Product : CRT monitor

Bulletin No. : 01-C/M-E0050

Model : AQ17HS/IS, AQ19IS/MS

SUBJECT : DY-Wire foaming change

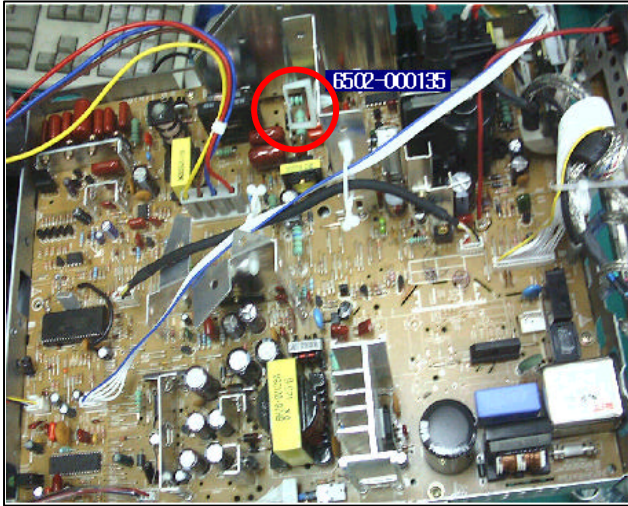
Background : DY-wire forming of AQ17HS/IS & AQ19IS/MS model have design problem.
 DY-wire can be touch with sharp edge of high voltage FET heat sink. this case, calbe could peel off.
 This peel off cause spark and some other accident.
 Samsung changed DY-wire clamp shape and forming method from Nov.01,2001

BEFORE

AFTER (long type)

Solution When repairing upper monitor model check wire condition.(if produced before Nov.2001)
 If wire and clamp shape is old version please change clamp and wire forming method.
 (refer to attached pictures)

Location No.	OLD (before) Parts		NEW (changed) Parts		* I.C
	SEC Code	Description	SEC Code	Description	
Cable clamp	6502-000135	DAWS-2NA,ID10,-,NTR,NYLON66	6502-001058	DAWH-50N,ID16.6,-,NYLON6/6,NTR	C
